# PUBLICATION INDEX

### SGS 1-23

K & L SOARING, LLC  
5996 STATE ROUTE 224  
CAYUTA, NY 14824

## 1-23 Service Bulletin Index

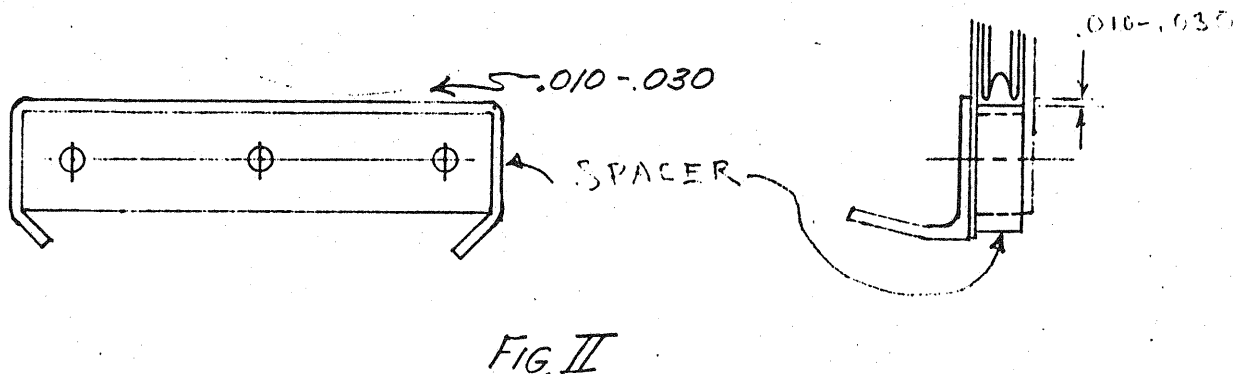
A case of spoiler control jamming has occurred on a 1-23G caused by excessive clearance between spacer block and spoiler control pulley just aft of main wing bulkhead fuselage, Sta. 76, near bottom of fuselage. This condition may exist in any of the above aircraft. The jamming has occurred only once and should not occur under normal conditions, but all aircraft should be checked and the correction below applied to eliminate this possibility. See Fig. I.

Check by using feelers inserted from aft end to determine gap between pulley and 23D117-2 block. If this exceeds .030, correction should be made as follows:

(1) Schweizer Aircraft Corp. can furnish an oversize blank 23D117-2 replacement which can be installed to bring the clearance between .010 to .030. Since this is difficult to do in the field due to the confined space, the alternate method No. 2 may be used.

(2) A spacer can be inserted as shown in Fig. II.

This spacer is made of soft aluminum sheet 3S4H, 32S0, 24S0, etc. 5/16" wide.

FIG. V

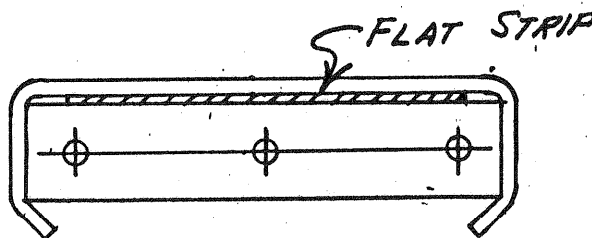
If more than .093 is required, use a flat strip 5/16" wide between the space and the block as shown in Fig. V.

Schweizer Aircraft Corp. will furnish the spacers on request specifying the thickness required.

**FIGURE 1 – ENGAGEMENT OF TOW HOOK INTO RELEASE ARM**

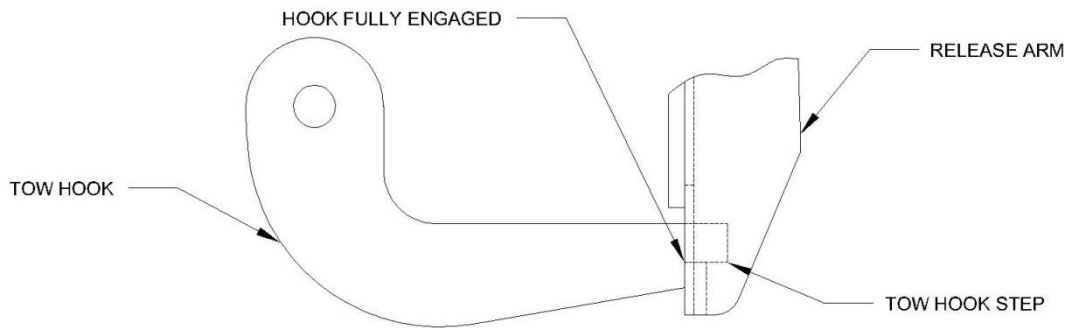
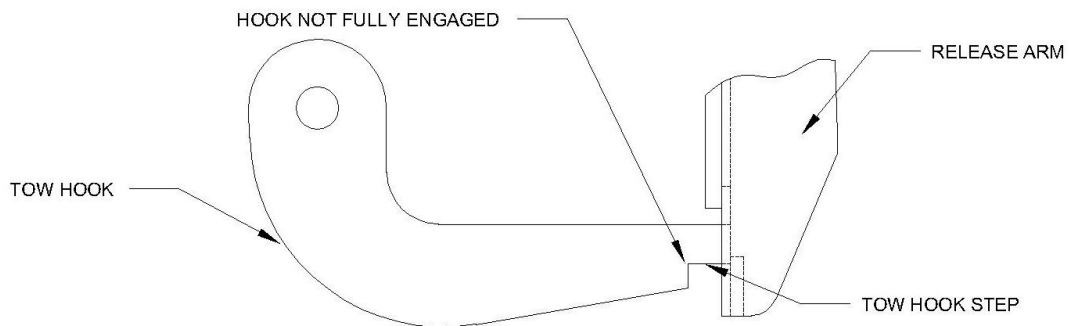
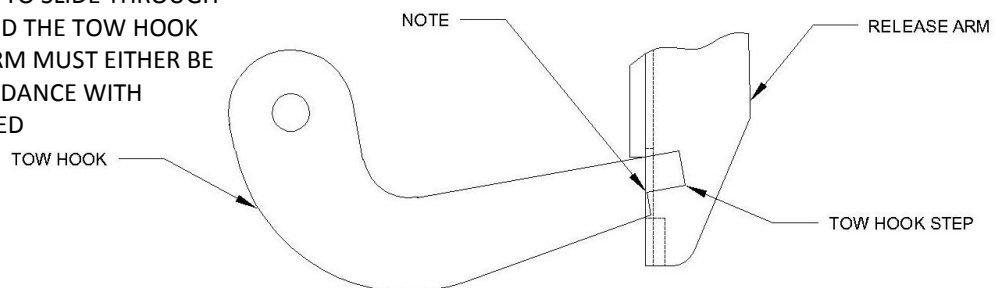
- Figure 1 shows the proper attachment of the tow hook into the release arm. Note that the step of the tow hook should seat against the release arm. The tow hook step must fully engage the release arm to allow the release assembly to function properly. The tow hook must not be allowed to extend through the release arm beyond the step on the hook as shown in Figure 1, View C.

IF TOW HOOK IS ABLE TO SLIDE THROUGH RELEASE ARM, BEYOND THE TOW HOOK STEP, THE RELEASE ARM MUST EITHER BE REWORKED IN ACCORDANCE WITH FIGURE 3, OR REPLACED

- g. If tow hook is able to travel too far inboard as shown in Figure 1, View C, disengage tow hook from release arm and measure the length of the release arm slot
- h. If dimension is less than 0.66 inch, rework release arm by welding on 1B-217-19 slug at location shown in Figure 3. (Release arm may be replaced as an alternate to welding on slug)
- i. If length of release arm slot is greater than 0.66 inch, replace release arm.
- j. Perform a thorough inspection of the tow hook installation in accordance with the 100 hour inspection requirements listed in Table 2 of this bulletin.
- k. Repair or replace unserviceable component(s), as required
- l. Record compliance with Part I of this Service Bulletin in Aircraft Log Book.

FIGURE 2 – TOW HOOK INSPECTION AND REWORK (SHEET 1 OF 2)

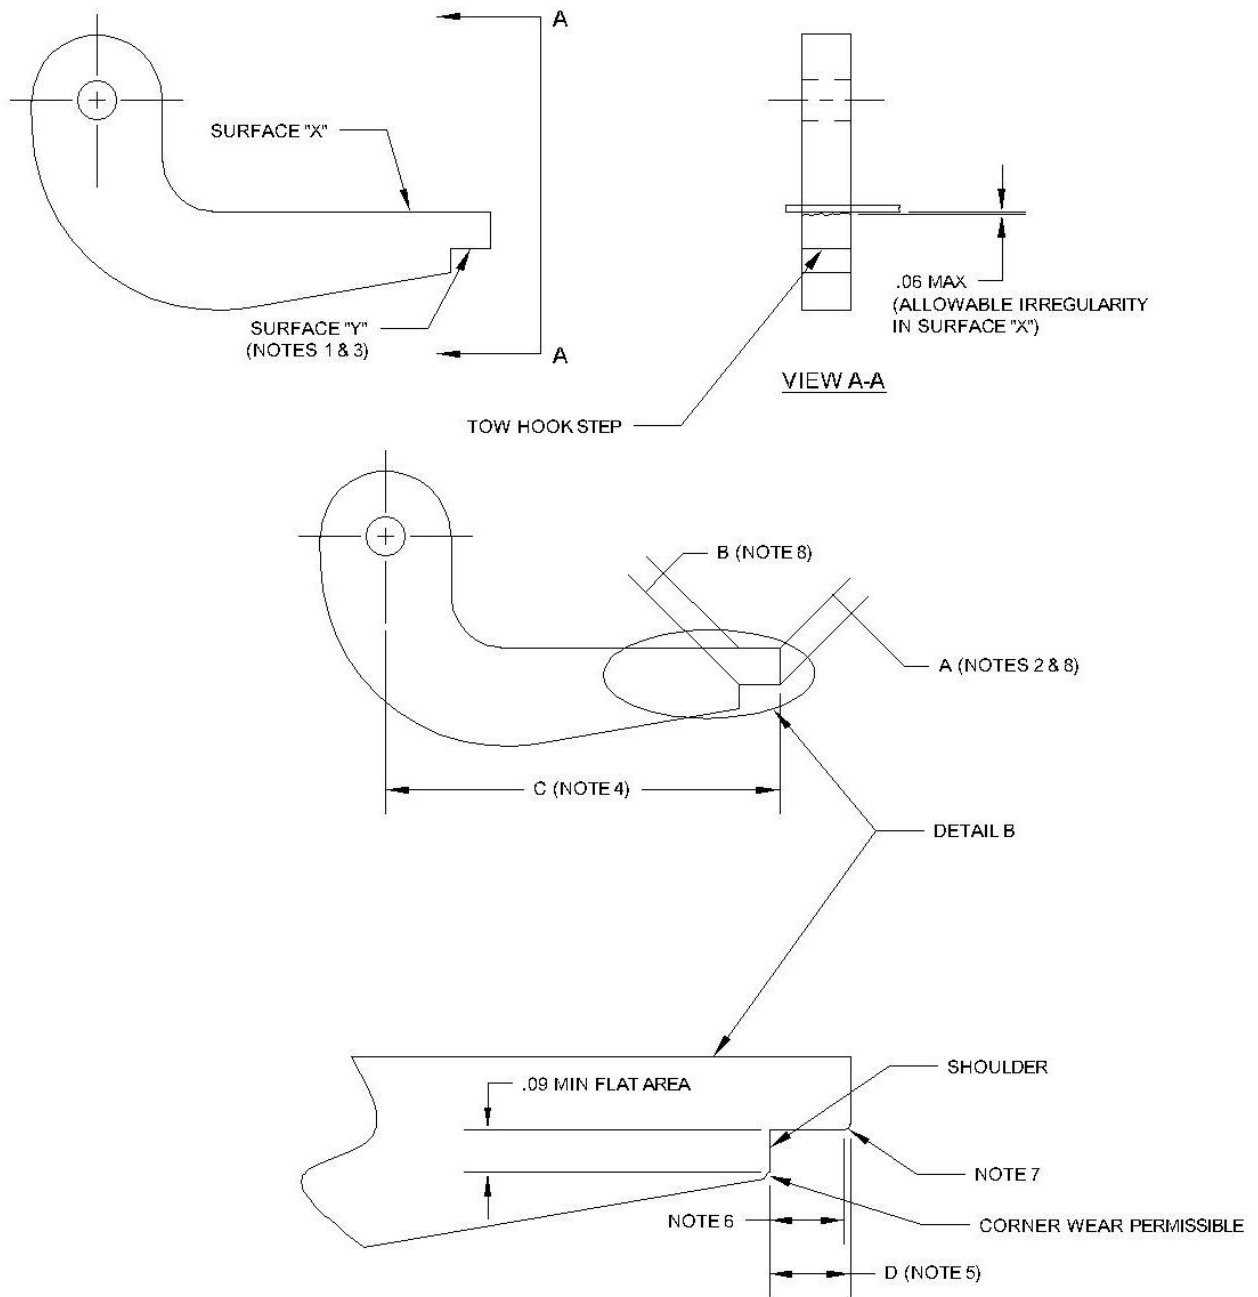
1. IF WEAR OCCURS ON SURFACE "Y" IT MUST BE POLISHED FLAT WITHIN TOLERANCES PROVIDED IN FIGURE 2 (SHEET 1). IF THE HOOK CANNOT MEET THESE REQUIRED DIMENSIONS IT MUST BE REPLACED. UNDER NO CONDITIONS SHOULD SURFACE "X" BE POLISHED OR MACHINED TO CHANGE ITS ANGLE.

2. DIMENSION "A" ON STD 10232-001 HOOK SHALL BE .21 INCHES MIN. & .28 INCHES MAX. DIMENSION "A" ON STD 1A218-1A, STD 1B221-3, & R-200-9A HOOKS SHALL BE .25 INCHES MIN. & .31 INCHES MAX.

3. SURFACE "Y" MUST REMAIN FLAT, SMOOTH, AND WITHIN TOLERANCES SHOWN ON SHEET 1. (SEE ILLUSTRATION).
4. DIMENSION "C" ON STD 10232-001 HOOK SHALL BE  $2.06 \pm .03$  INCHES. DIMENSION "C" ON STD 1A218-1A, STD 1B221-3, & R-200-9A SHALL BE  $3.00 \pm .03$  INCHES.

5. DIMENSION "D" ON STD 10232-001 HOOK SHALL BE  $.25 \pm .03$  INCHES. DIMENSION "D" ON STD 1A218-1A, STD 1B221-3, & R-200-9A SHALL BE  $.31 \pm .03$  INCHES.

6. HOOK MUST REMAIN FLAT IN THIS AREA FOR A MIN. OF .21 INCHES FROM SHOULDER OF HOOK.
7. WEAR OUTSIDE OF THE .21 MIN. FLAT AREA IS PERMISSABLE.
8. DIMENSION "B" MUST BE EQUAL TO DIMENSION "A", OR LESS THAN DIMENSION "A" BY NO MORE THAN .015 INCHES AND CANNOT BE GREATER THAN DIMENSION "A".

9. ALL SURFACES EXCEPT SURFACE "X" MAY BE FILLED TO OBTAIN REQUIRED DIMENSIONS.

- d. If tow hook dimensions are not within limits specified in Figure 2, either rework the tow hook to obtain dimensions (as specified in Figure 2) or replace it with a new or serviceable, used tow hook
- e. Engage tow hook into release arm. Ensure that the tow hook properly engages as shown in Figure 1, View A.
- f. If tow hook is unable to completely engage (shown by Figure 1, View B) shorten the rubber bumper stop between the release knob and the instrument panel to allow the release assembly to close further.

FIGURE 3 - REWORK OF RELEASE ARM

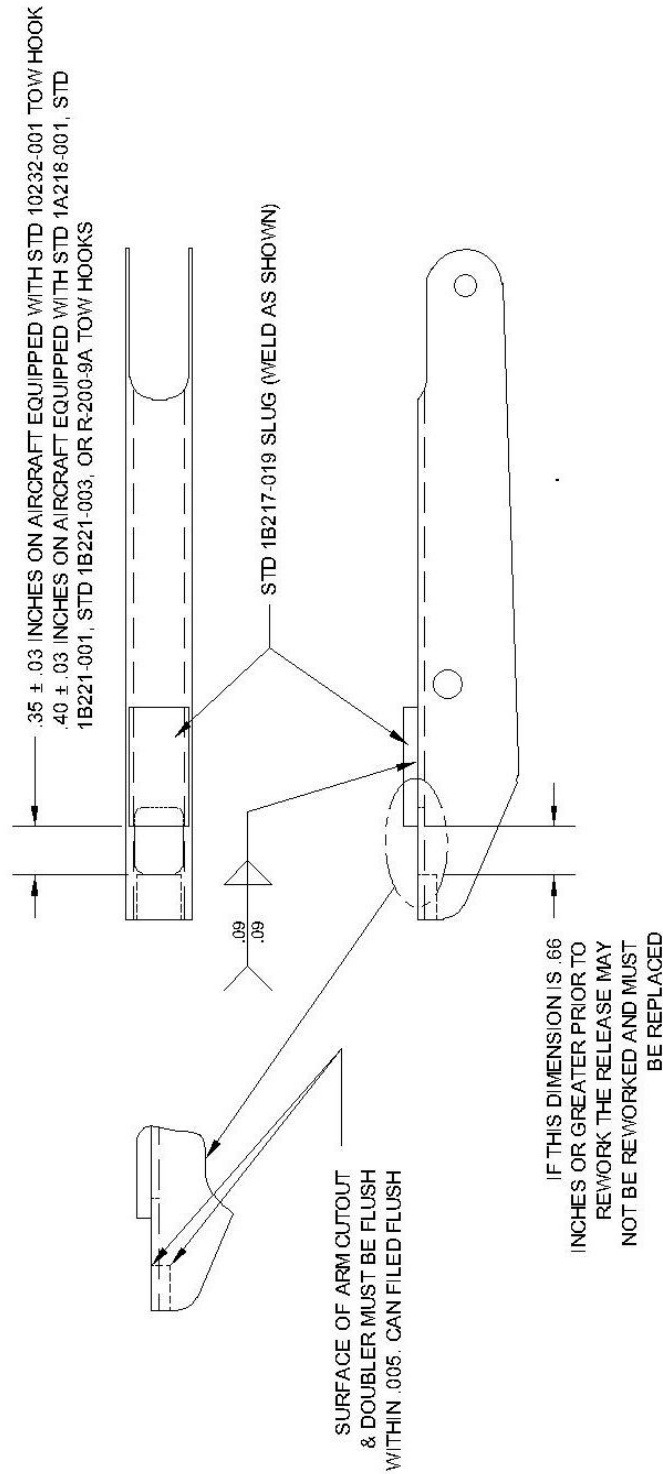
NOTE: STD 1B217-019 SLUG IS AVAILABLE FROM K & L SOARING, LLC  
0.125 X 0.5 X 1.0 4130N STEEL

NOTE: ALL TOW RELEASE ARMS MUST BE REWORKED AS SHOWN ABOVE OR REPLACED WITH THE PROPER SUPERSEDING ARM AS SPECIFIED IN TABLE 1

FIGURE 4 - PULL TEST OF TOW RELEASE ASSEMBLY

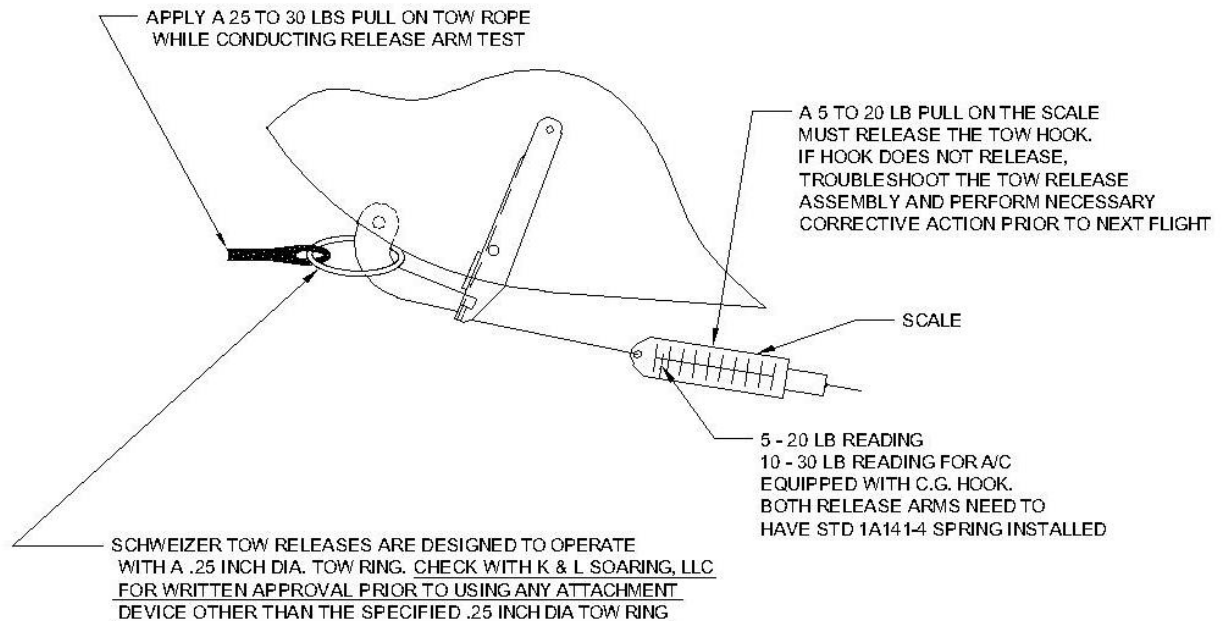
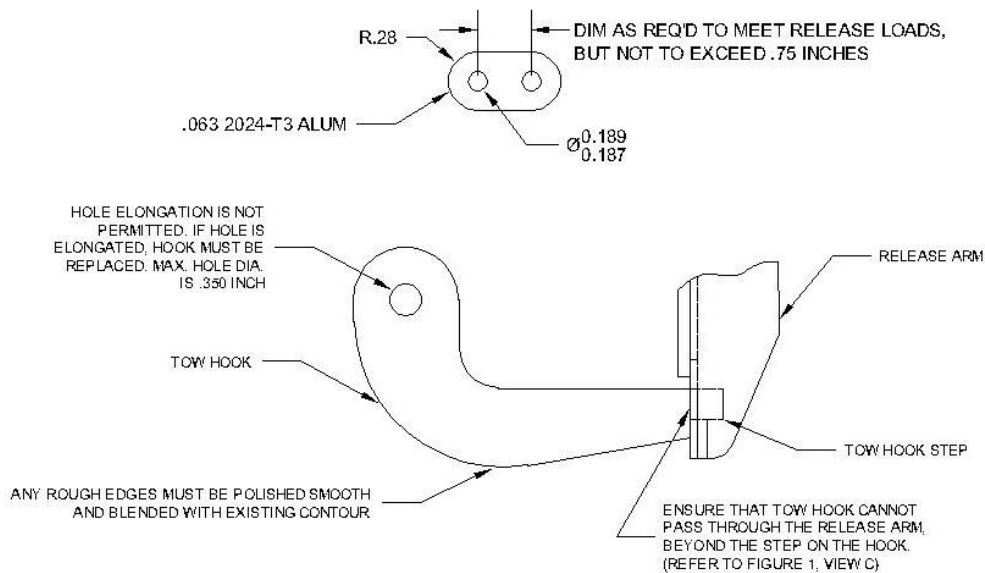
NOTE: IF RELEASE LOADS ARE TOO HIGH WITH C.G. SYSTEM IT IS PERMISSIBLE TO ADD A LINK TO SHORTEN STD 1A141-2 SPRING. LINK SHOULD BE MADE AS SHOWN BELOW. IF REQUIRED THEY SHOULD BE ADDED TO BOTH RELEASE ARMS TO BALANCE BOTH RELEASE SPRINGS
